**Addendum No. 002**

**Subject: 2020 Classroom Modernizations**  
**SDP Contract Numbers: B-007 C of 19/20 & B-009 C of 19/20**

**Location: George Sharswood School**  
**2300 S. 2nd St, Philadelphia PA 19148**

**This Addendum, dated February 27, 2020, shall modify and become part of the Contract Documents for the work of this project. Any items not mentioned herein, or affected by, shall be performed strictly in accordance with the original documents.**

5 KINDERGARTEN - ROOM 105  
1/4" = 1'-0"

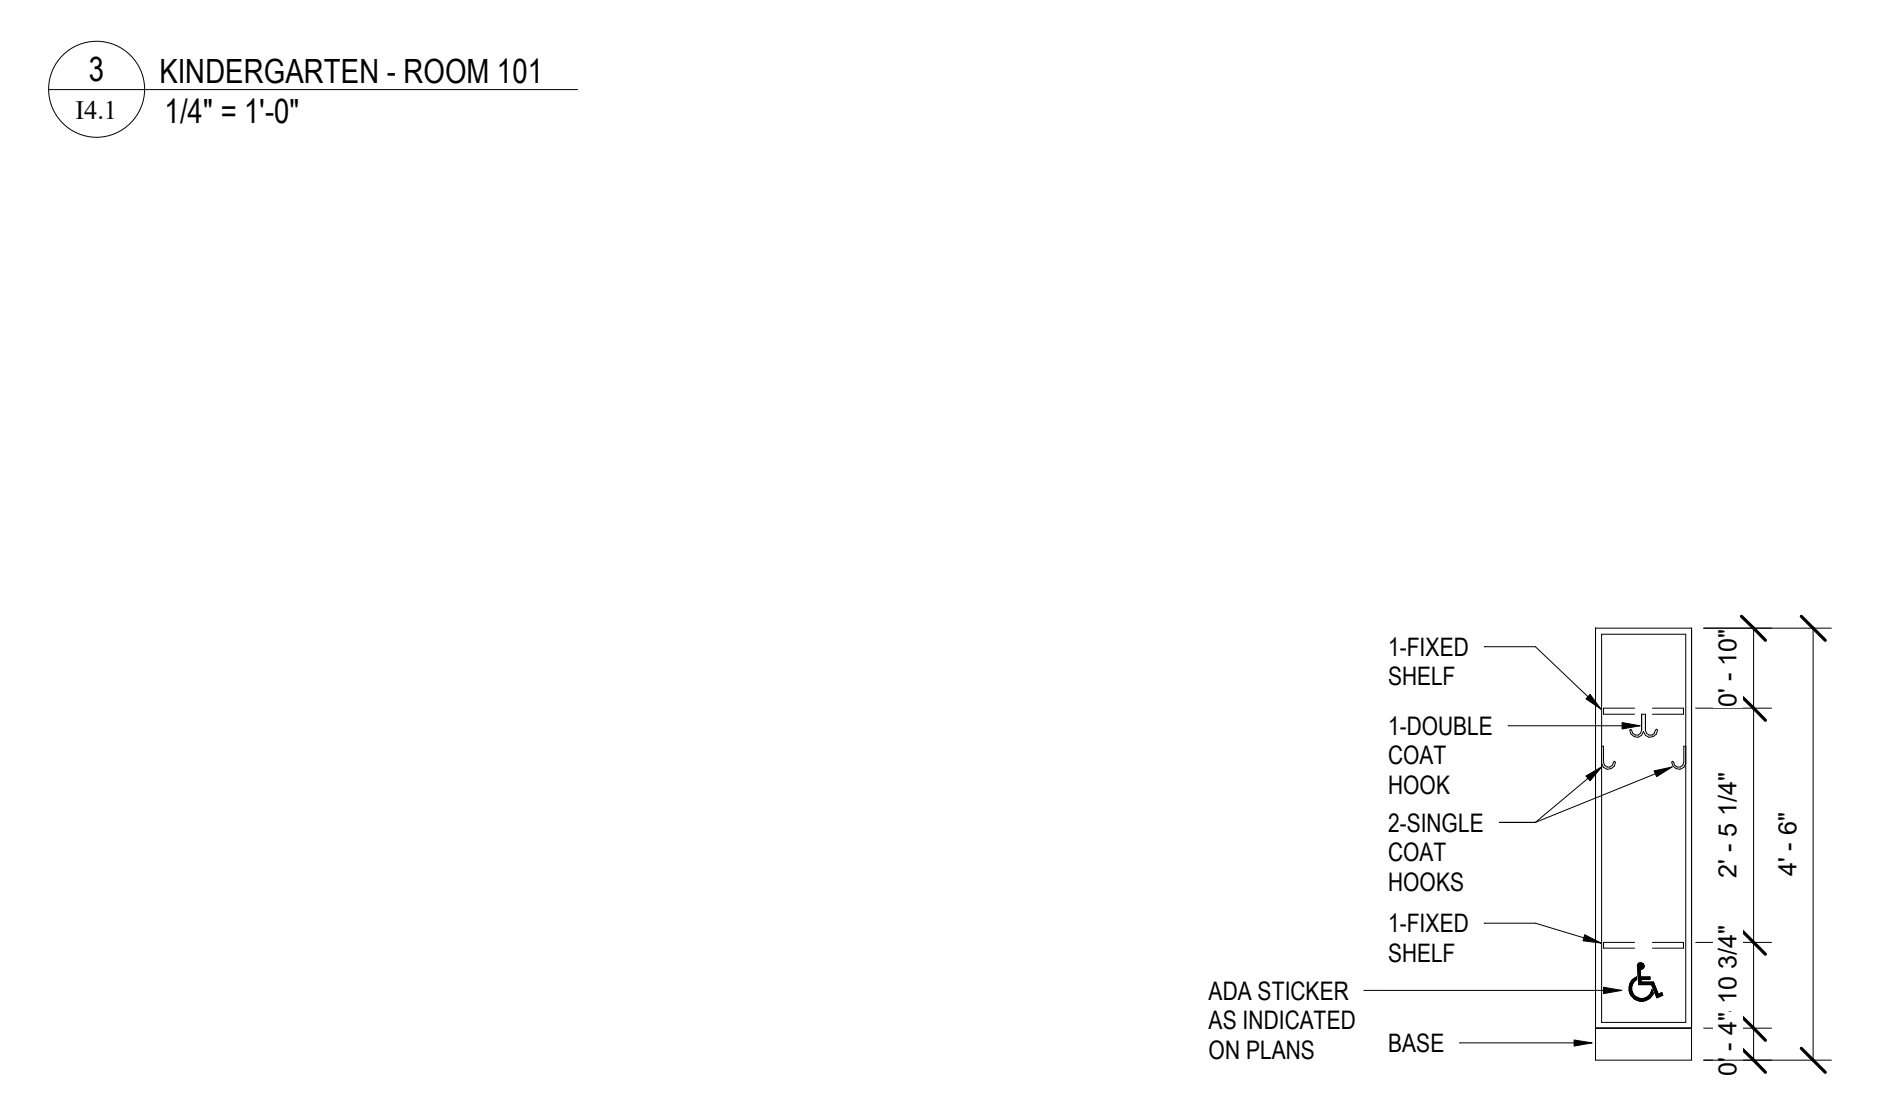
1. REVISED detail 5/I4.1 KINDERGARTEN – ROOM 105 – Revise 704 & 706 to 703. Align Smart Board with right edge of Visual Display board.

5 SPECIAL EDUCATION - ROOM 108  
1/4" = 1'-0"

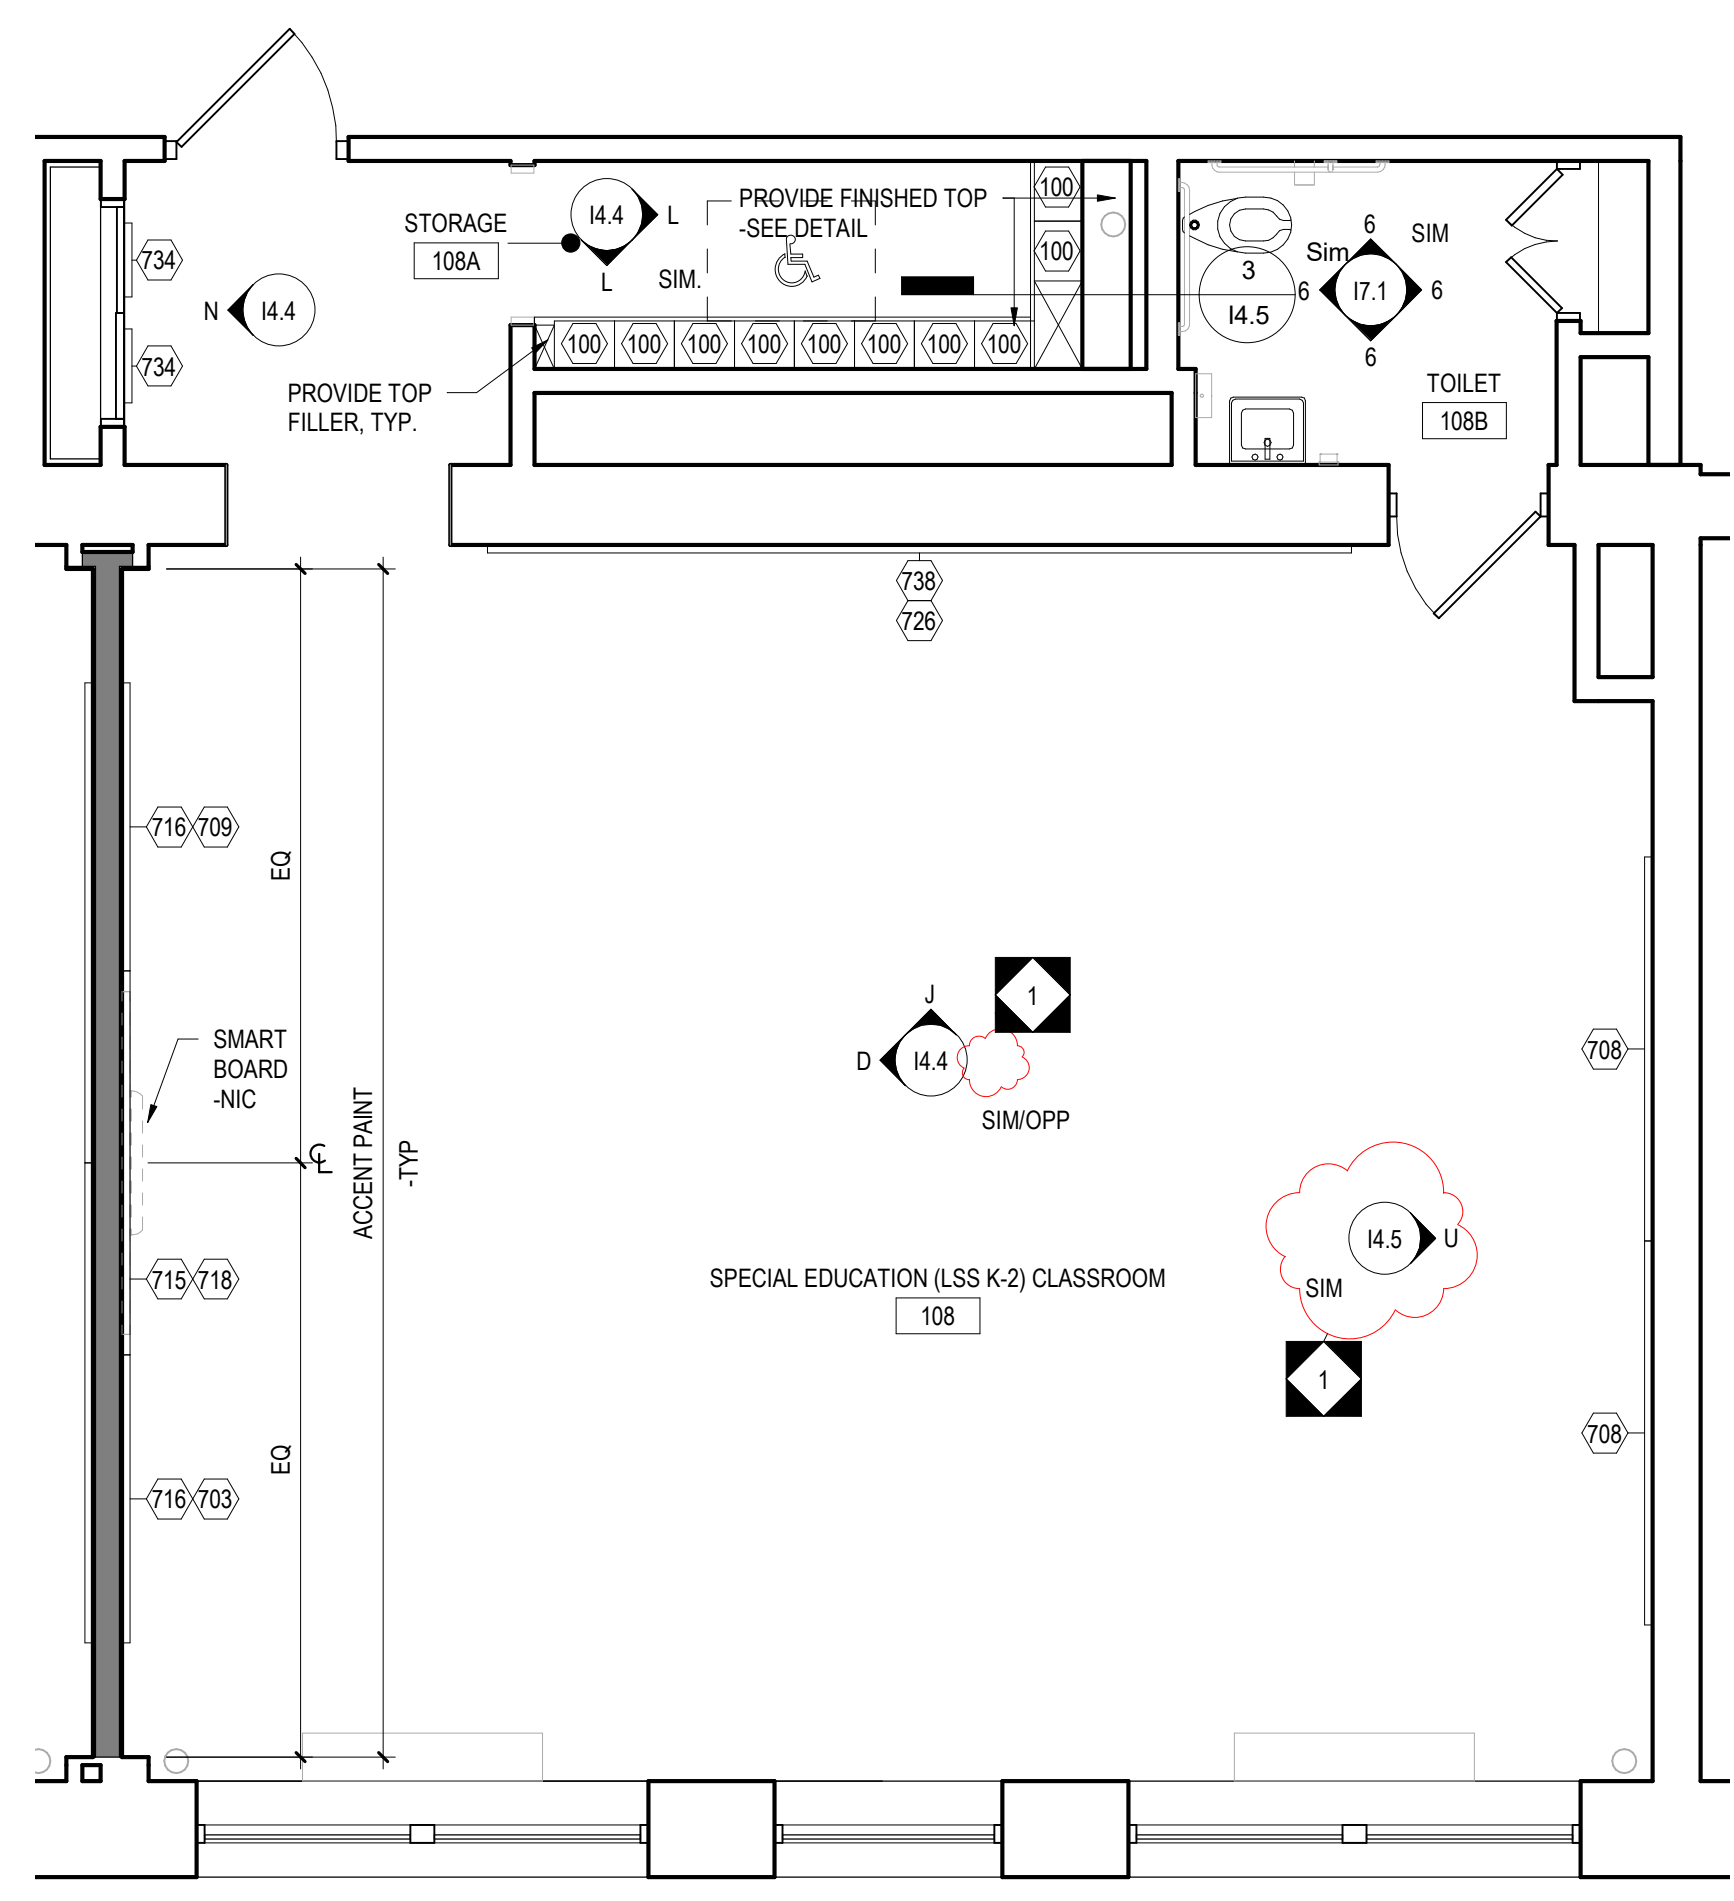
1. REVISED detail 5/I4.3 SPECIAL EDUCATION – ROOM 108 – Revised elevation indicator plan right to detail U/I4.5 “EXISTING BUILT-IN DISPLAY WALL - ROOM 223 & DISPLAY WALL - ROOM 108”.

U EXISTING BUILT-IN DISPLAY WALL - ROOM 223 & DISPLAY WALL - ROOM 108  
14.5 1/4" = 1'-0"

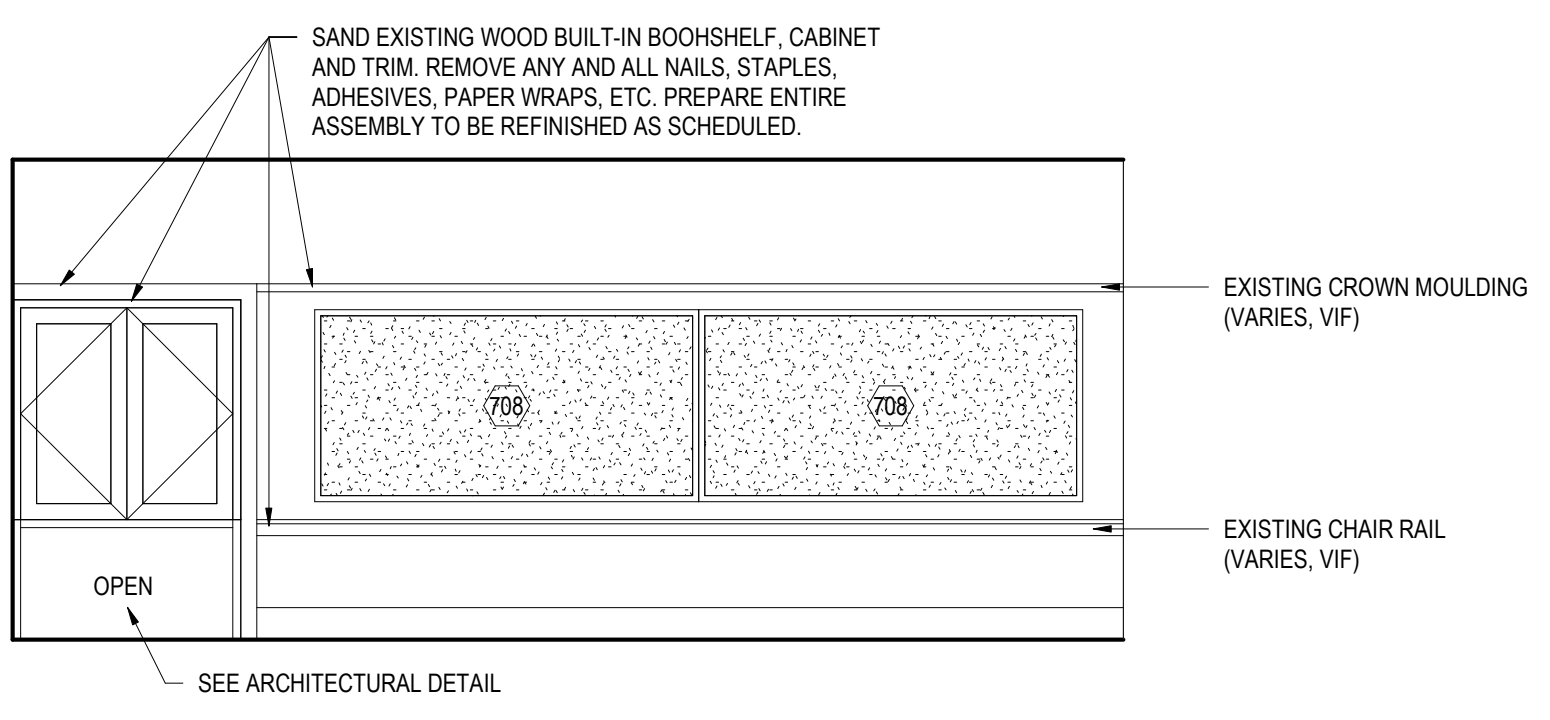
1. REVISED detail U/I4.5 to read as follows: “EXISTING BUILT-IN DISPLAY WALL - ROOM 223 & DISPLAY WALL - ROOM 108”.

1 ELECTRICAL FIRST FLOOR POWER PLAN  
E2.1 1/8" = 1'-0"

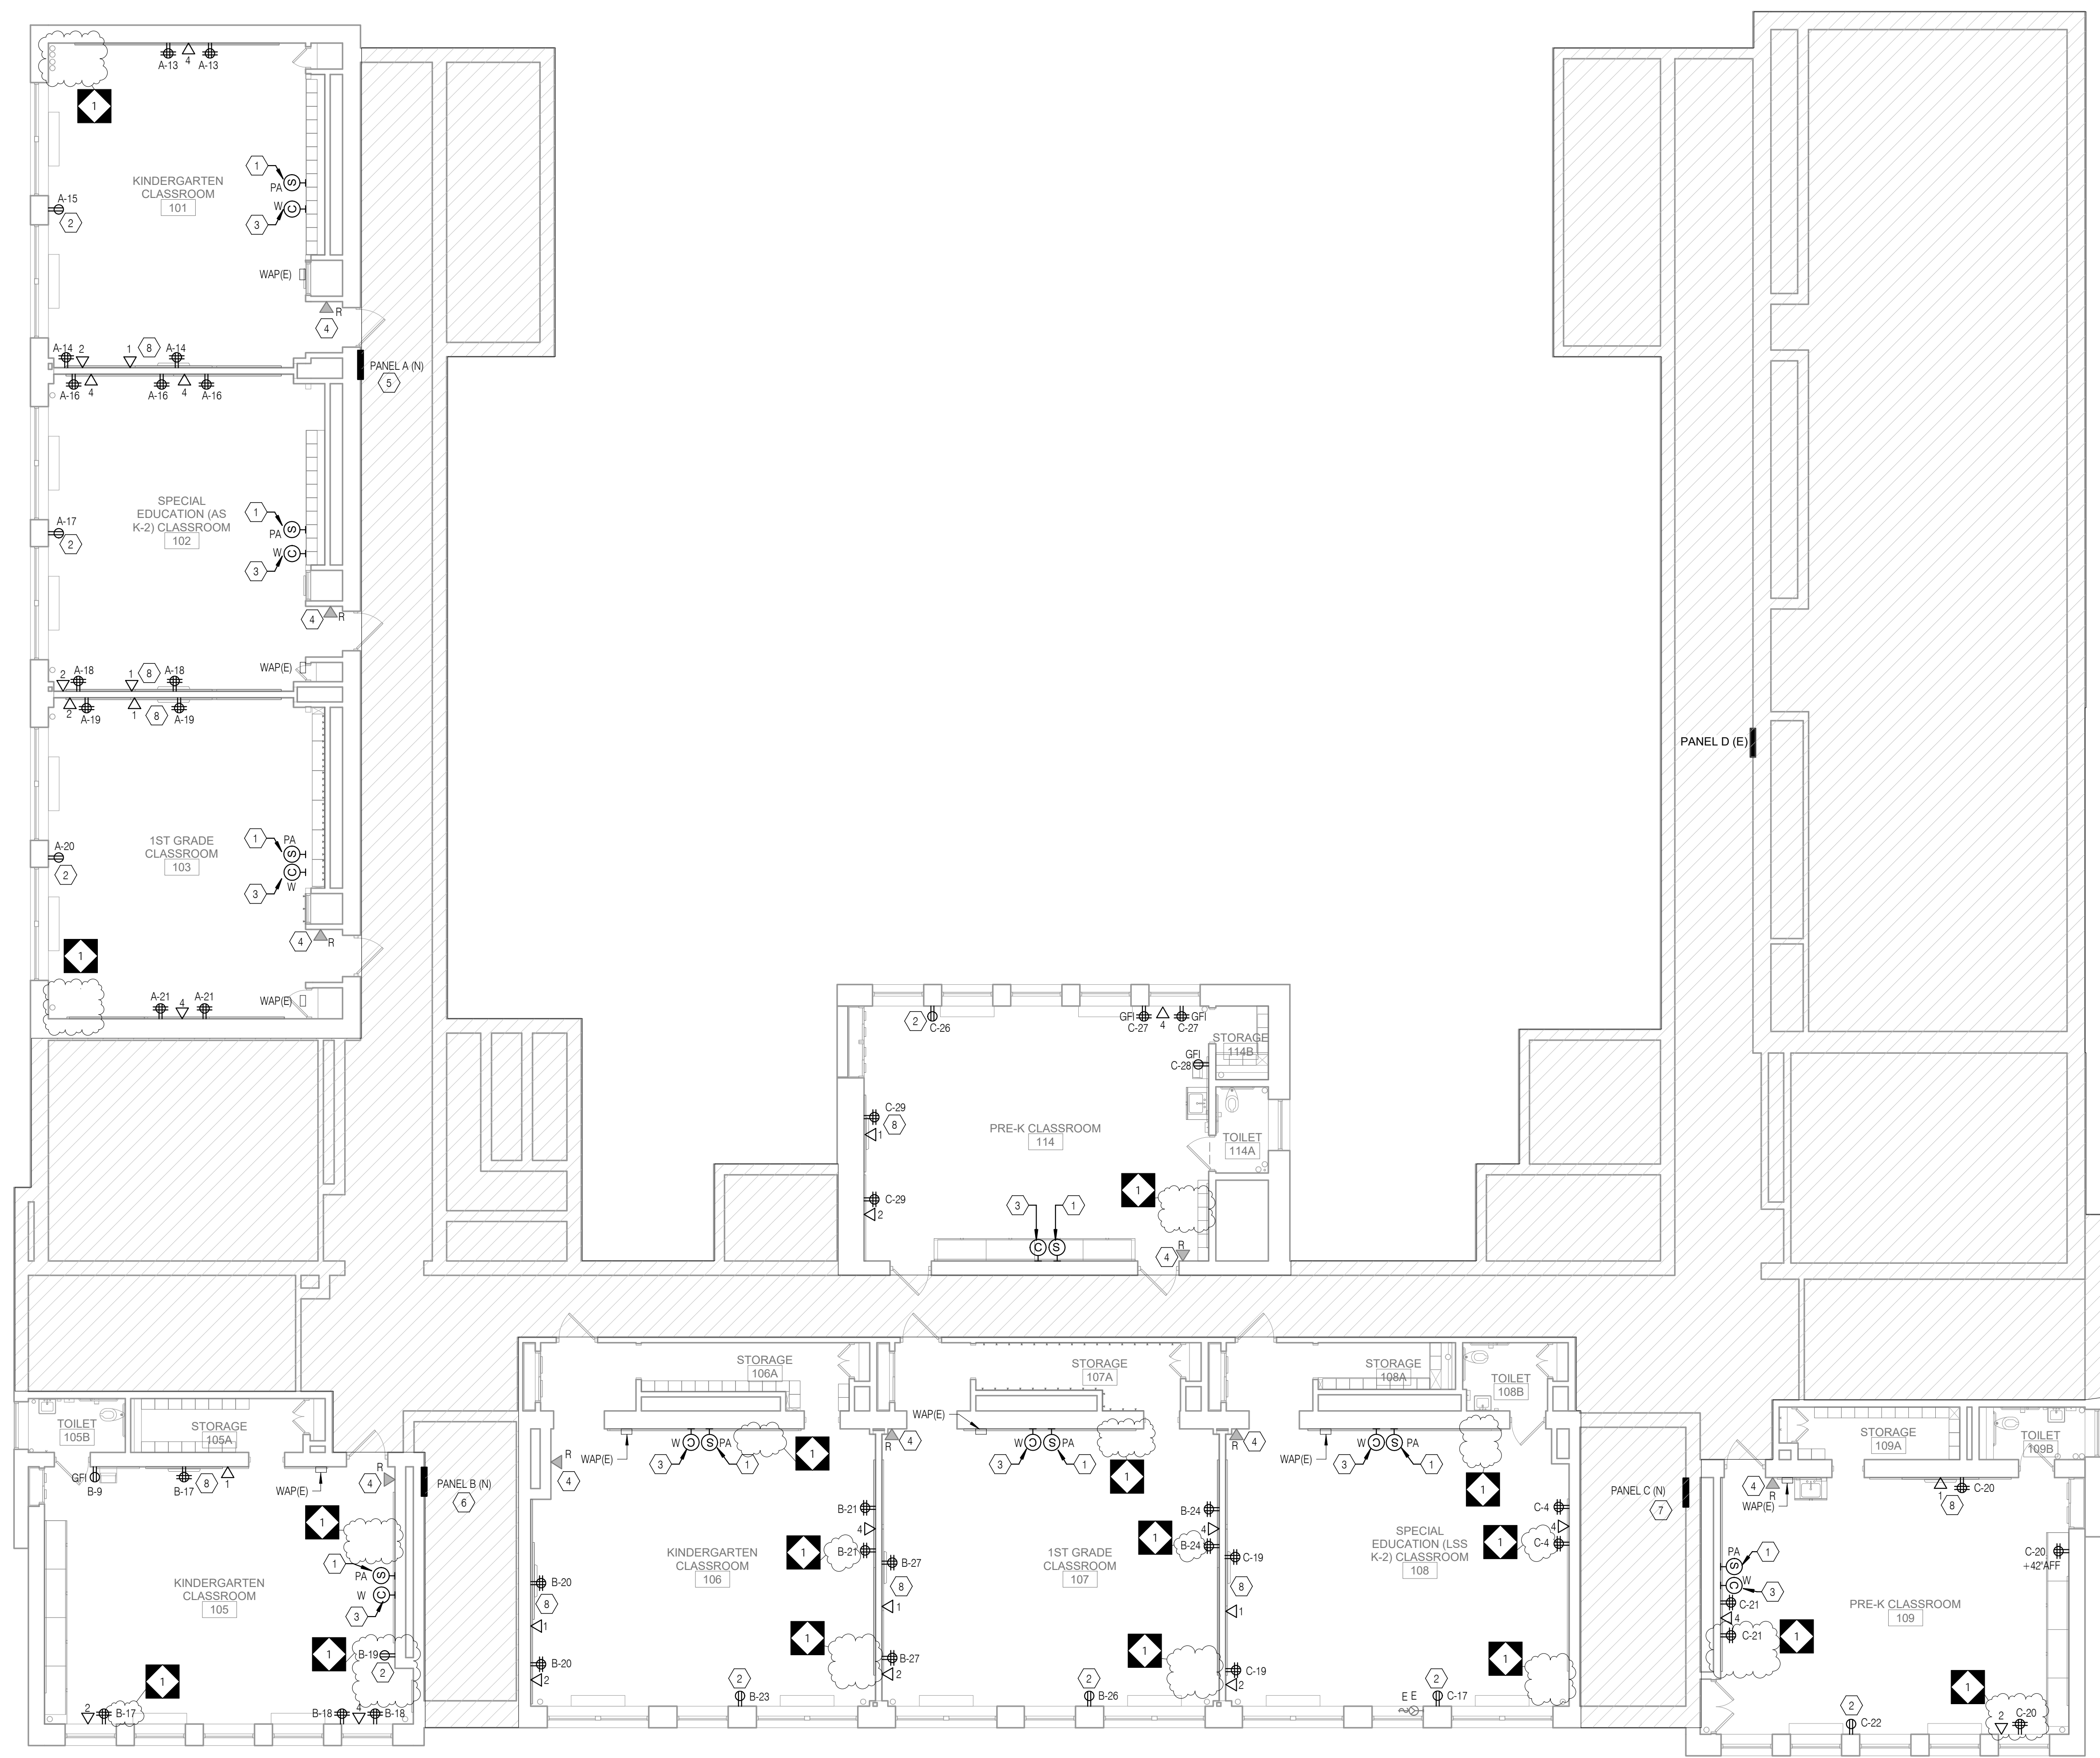
1. ADD General Sheet Note #6 to read "ELECTRICAL CONTRACTOR TO RUN ALL NEW SURFACE MOUNTED CONDUITS AND RACEWAYS IN CORNERS OF EACH CLASSROOM TO AVOID CONFLICT WITH DISPLAY BOARDS AND OTHER CLASSROOM FURNISHINGS."
2. REVISE power and data layout as indicated on the drawings.
3. CLARIFY where panel is called to be semi-recessed, contractor shall cut the glazed block wall to accommodate the panels. A surface mounted panelboard will cause a 6" intrusion into the path of egress, which is not permitted.
